# Technical Service Bulletin

<b>Subject:</b>  CREAKING NOISE FROM STEERING COLUMN	<b>Bulletin No.:</b> 06-004/23
	<b>Last Issued :</b> 07/17/2023

2016-2023 CX-9 vehicles with VINs lower than JM3 TC\*\*\*\* \*\* 657869 (Produced before Mar. 13, 2023)

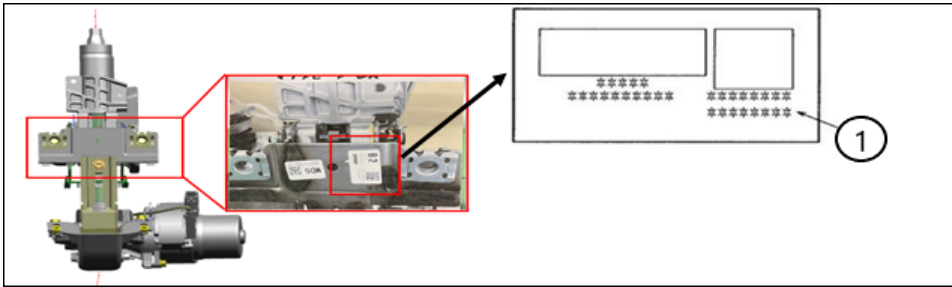
Verify the lot number printed on the sticker (1).

The first digit indicates the year of the production date, the second is the month, the third and the fourth are the day.
